Application for Licence

| Licence Number | L9380/2023/1 |
| Applicant | WA Kaolin Limited |
| Premises | <p>Kaolin Mine and Process Plant 330 Sparks Road EAST WICKEPIN WA 6370</p> <p>Legal description – Mining tenement M70/1143 As defined by the premises maps attached to the issued licence.</p> |

Figure 2: (A) Infrastructure and (B) process flowsheet of kaolin de-gritting at premises

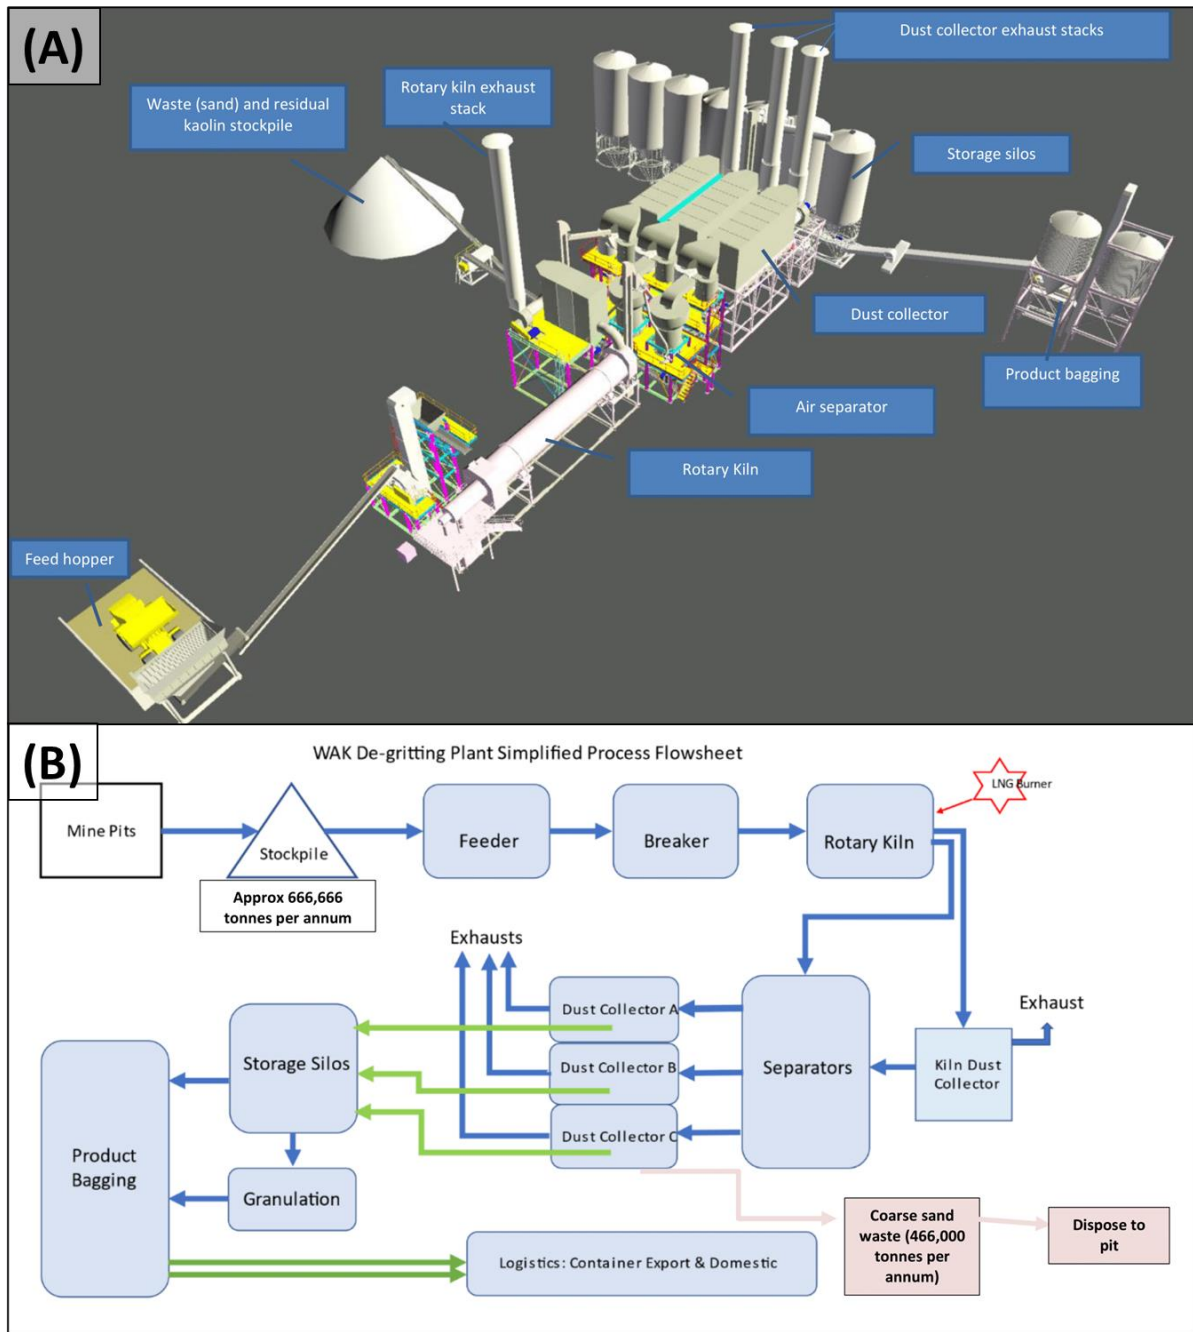
| Condition | Summary of applicant's comment | Department's response |
|-------------|---|--|
| Figure 2 | The applicant provided an updated figure, as requested by the department. | |
